Louisiana Coastal Protection and Restoration

Fish and Wildlife Service Planning Aid Report

Plan Formulation Planning Aid Report

**Provided to
New Orleans District/Vicksburg District
U.S. Army Corps of Engineers**

Figure 7. FWS proposed Avoca Island Extension Levee breach and alternative breach location at Avoca Island.

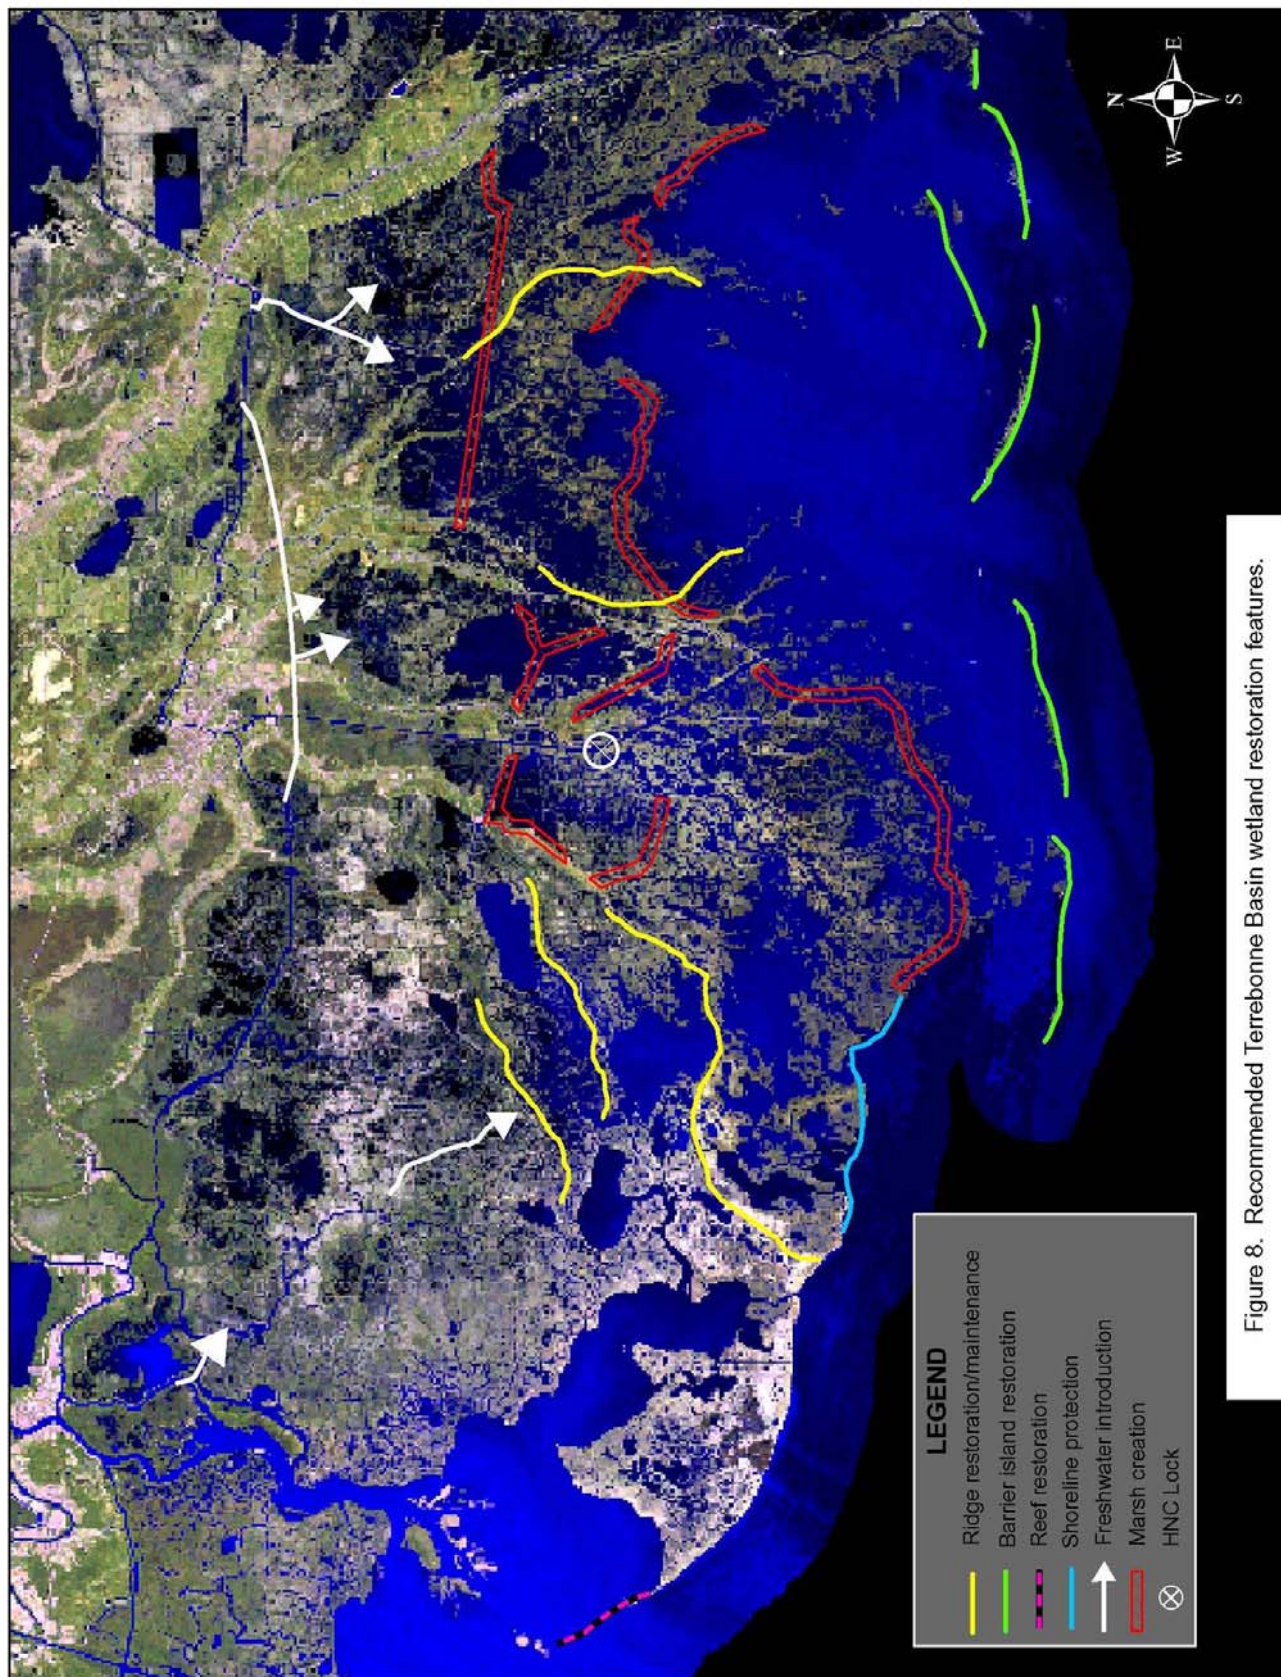
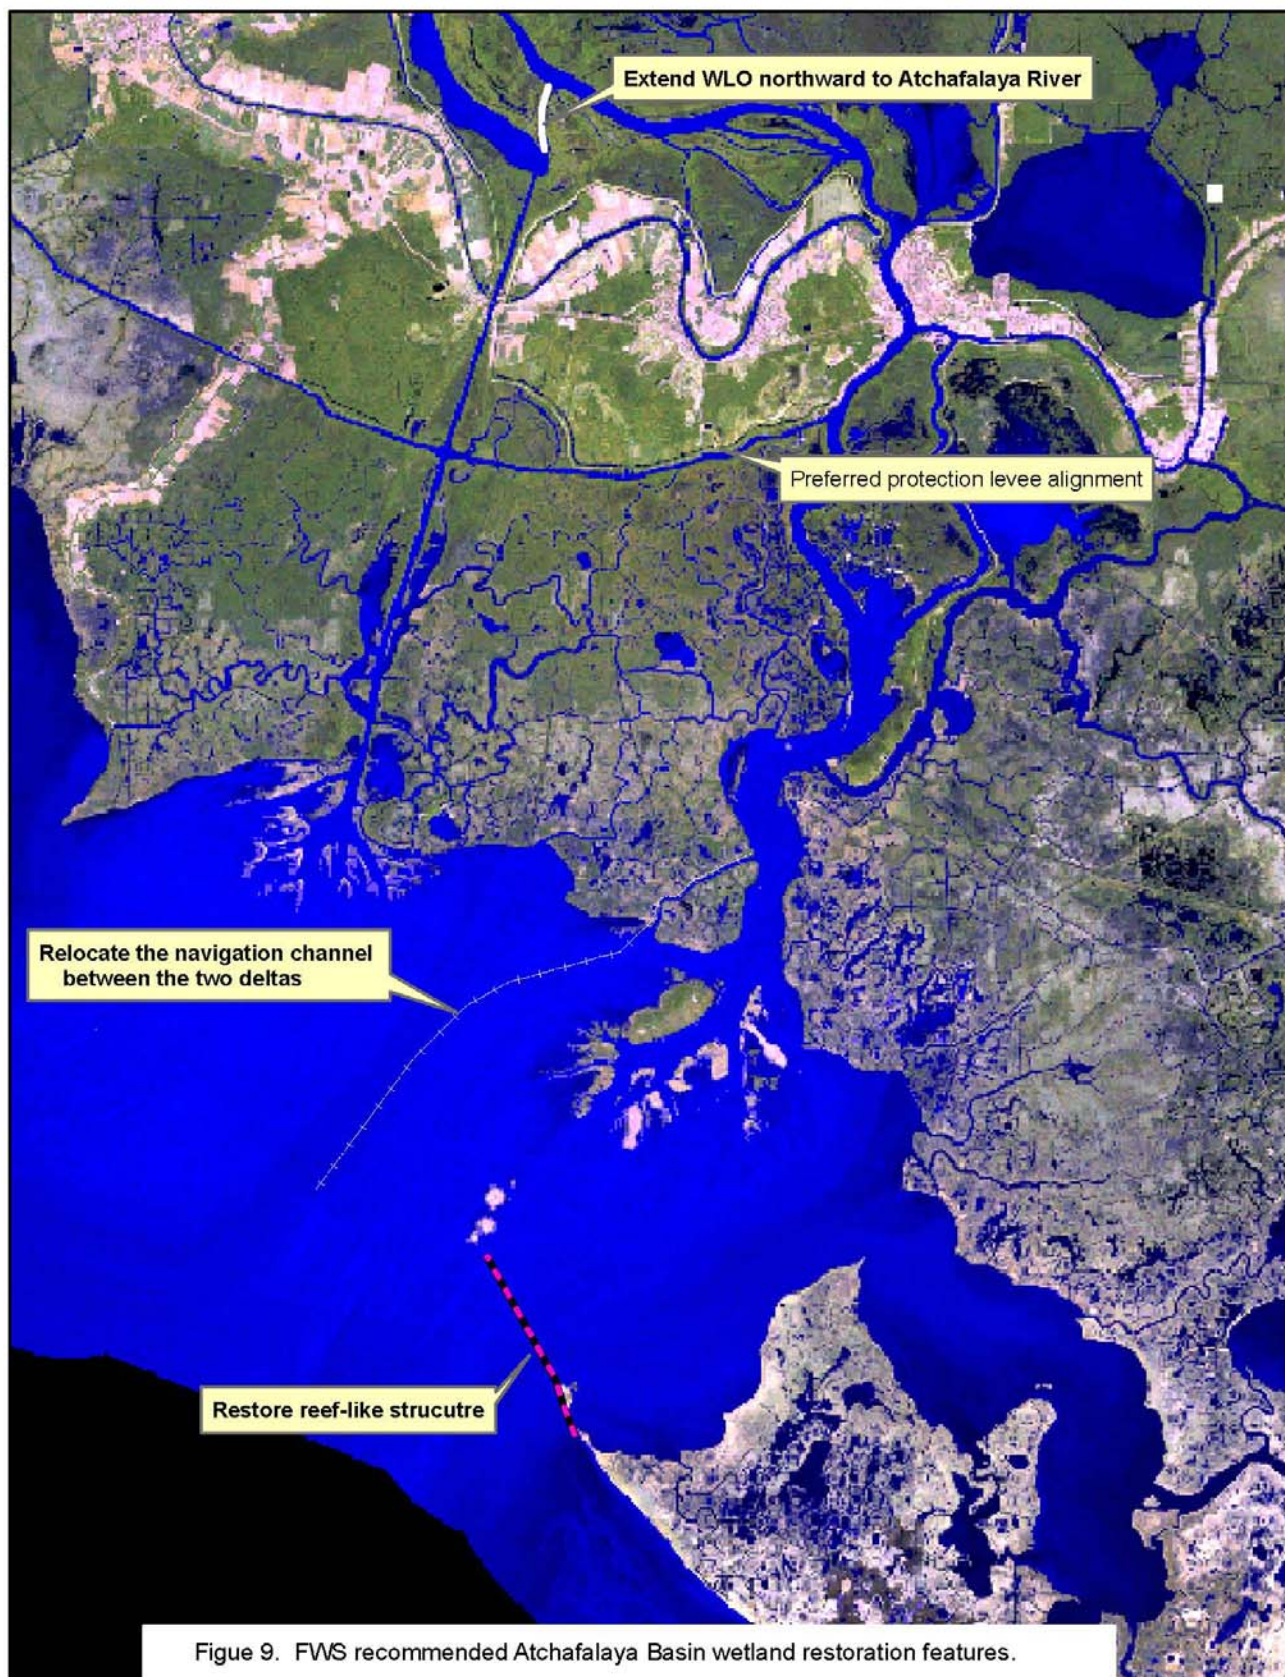
2. Connect Bayou Shaffer with the Avoca Island Cutoff Channel near the mouth of Bayou Penchant, or, direct all or part of Bayou Shaffer flows into Avoca Island. The Barrier Plan, or other means of protecting low-lying and flood prone areas within the Verret Subbasin would have to be completed as a prerequisite to avoid project-induced flooding. (S)

Figure 8. Recommended Terrebonne Basin wetland restoration features.

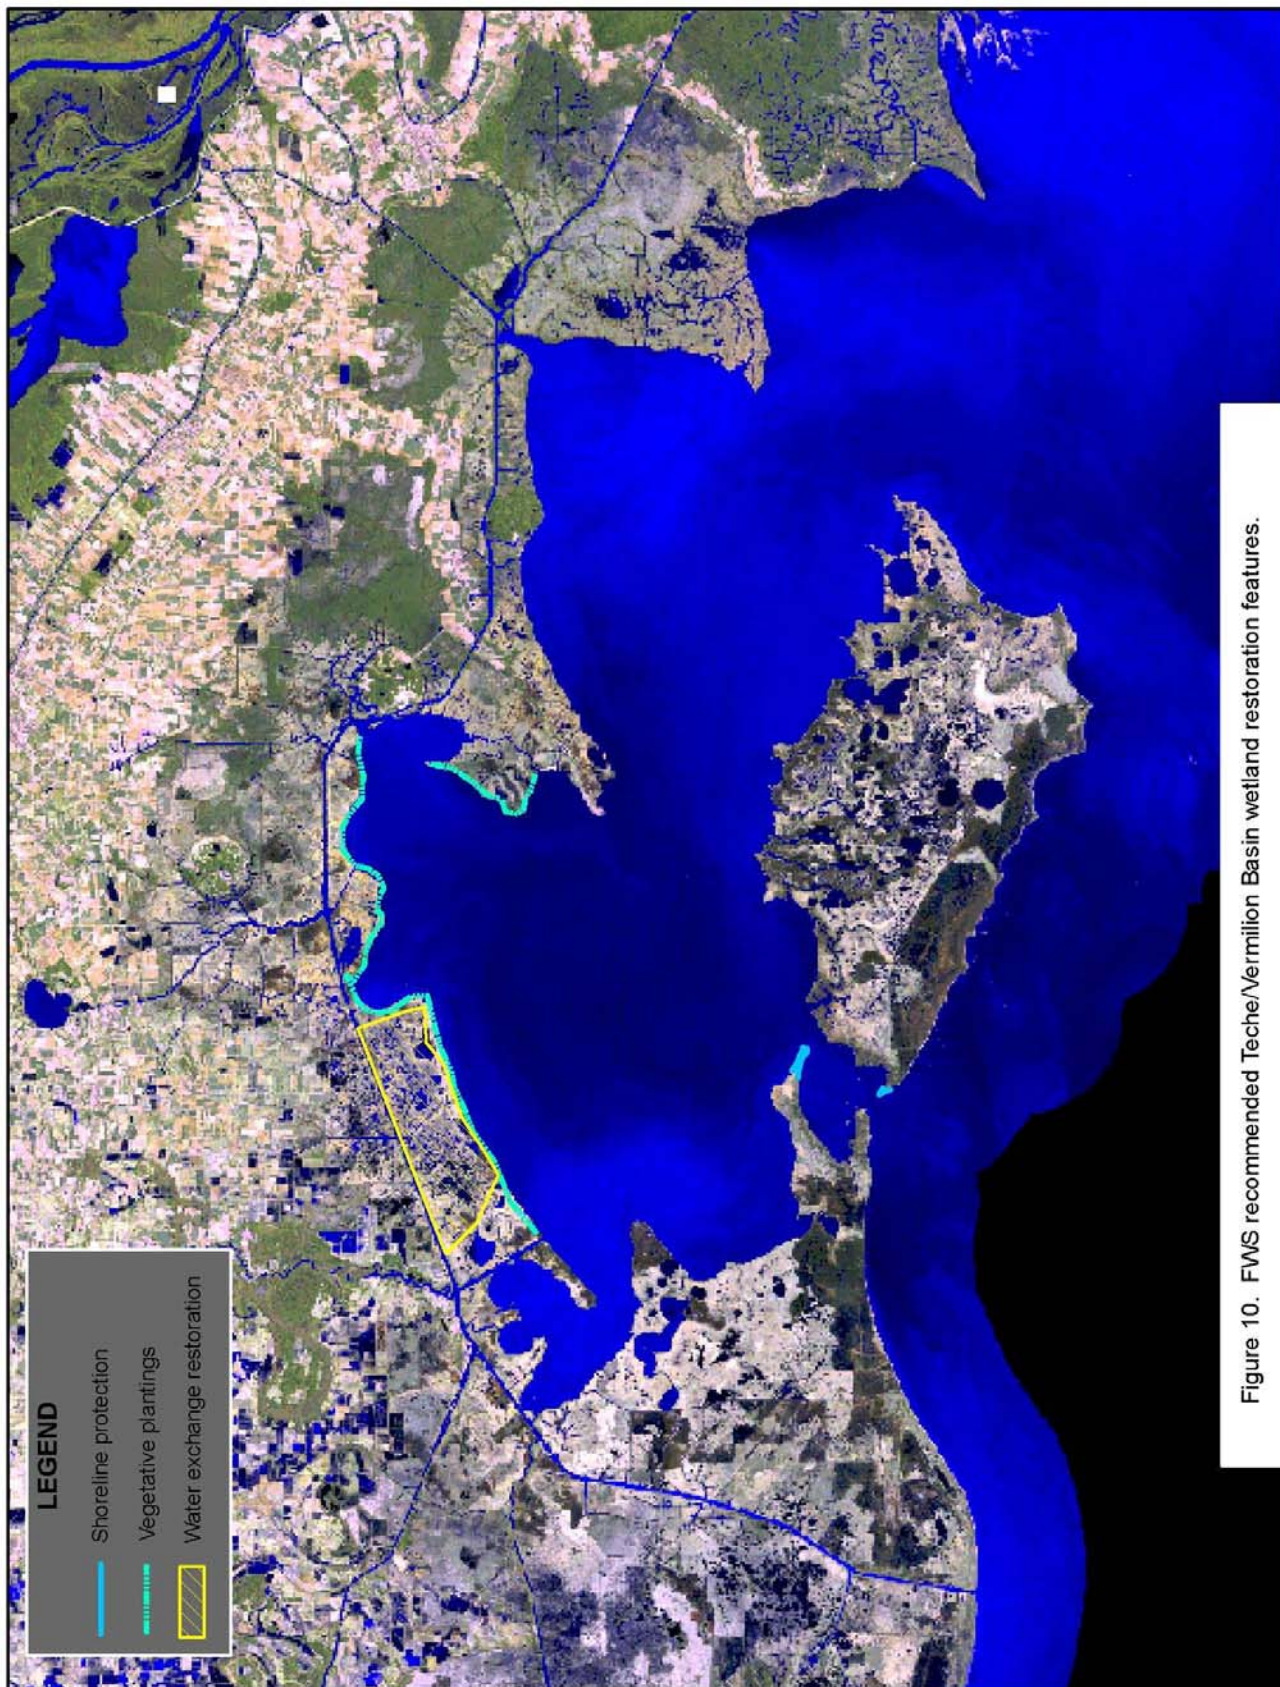
A less effective and complex alternative to the modified Third Delta feature would consist of a combination of features that would increase the introduction and distribution of Atchafalaya River freshwater into portions of central and eastern Terrebonne Basin. The Avoca Island Extension Levee could be breached to increase freshwater flows into the GIWW, and smaller channels could be constructed/enlarged to move that water from the GIWW to areas of need (Figure 7). However, the breaching of the Avoca Island Extension Levee could not be accomplished until the Barrier Plan or other protection features have been constructed to protect low-lying communities near Amelia and in the Verret Basin from riverine backwater flooding. The Avoca feature, combined with the construction of the Houma bypass channel (and associated smaller distribution channels) would provide substantial opportunities to move fresh water into central and eastern Terrebonne. Because those features would not introduce a substantial quantity of suspended sediments, they would not likely sustain the southernmost marshes. Hence, long-term existence of those marshes may require periodic re-nourishment through hydraulic sediment additions to compensate for subsidence. Installation of other protection or restoration features would also be required to halt erosion of wetlands along the northern bay fringes and along the shores of larger inland lakes (Figure 8).

7. Construct a band of marsh along the northern fringe of Lake Pelto, Terrebonne Bay, and Timbalier Bay. The southern edge of that marsh band would require erosion protection through rock armoring, sand placement, or reef construction. This marsh band would protect more inland marshes from erosion and would help to retain introduced freshwater and sediments. (I)

8. Elevate and widen subsided ridges (i.e., Marmande/Mauvois Bois, Small Bayou la Pointe, Bayou Dularge, Bayou Terrebonne, and Bayou Pointe au Chene. (I)

9. Create inland bands of marsh to reduce fetch across eroding marsh areas that are in danger of enlarging to become major lakes. Areas where such marsh bands would be constructed include the Bayou Rambio area between Bayou DuLarge and Grand Caillou, between Lakes Boudreaux and Quitman, and across the Timbalier Subbasin marshes along the "twin pipelines." (I)

Figure 10. FWS recommended Teche/Vermilion Basin wetland restoration features.

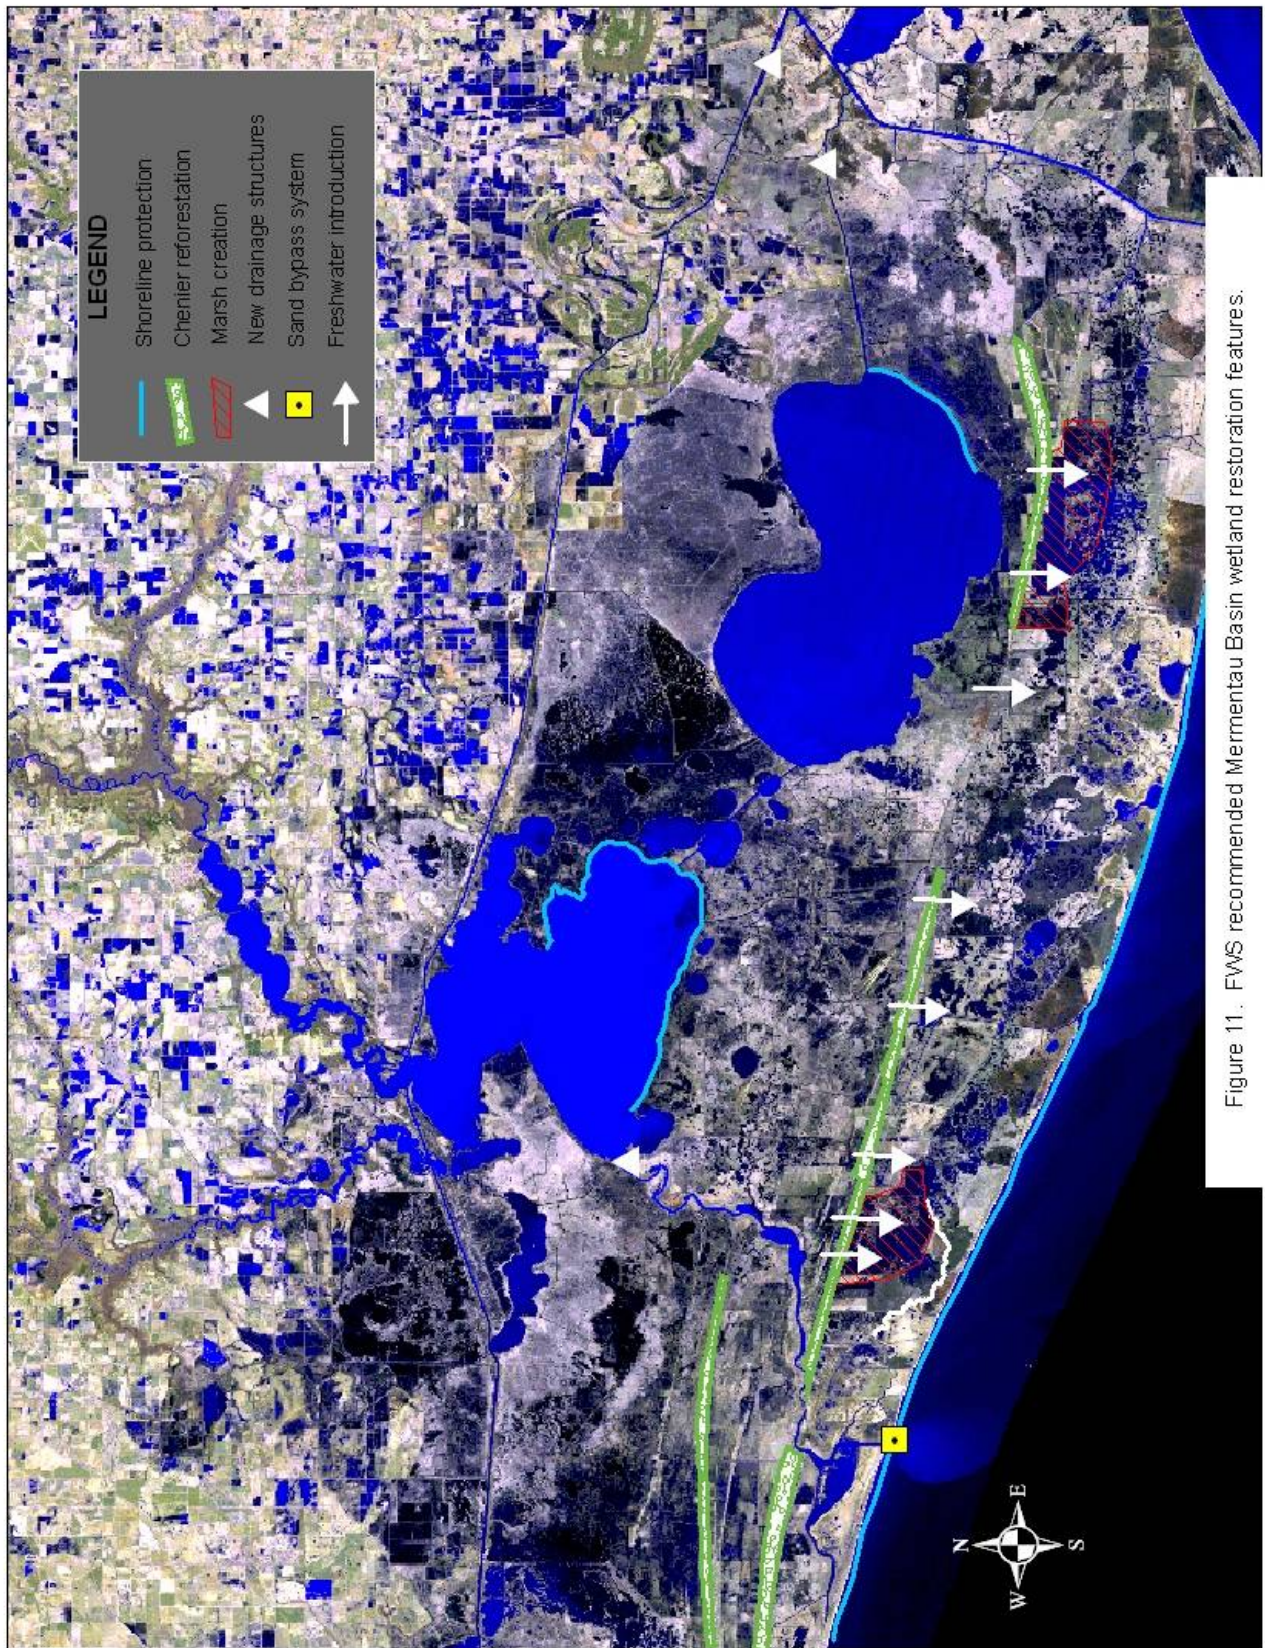
Wetland losses in this basin are low and are caused primarily by shoreline erosion or small-scale and site-specific problems. Wetland restoration recommendations (Figure 10) are designed to address some of those problems; otherwise, area wetlands are thought to be generally self-sustaining due to increasing inputs of suspended sediments from the WLO and Atchafalaya River. Specific restoration measures listed below are identified as either providing immediate storm surge protection benefits (I), or long-term, sustainable protection (S).

2. Conduct vegetative plantings or install shoreline protection measures along rapidly eroding sections of bay shorelines. (S)
3. To prevent Southwest Pass from enlarging, armor the eroding banks of Southwest Point and Lighthouse Point. (S)
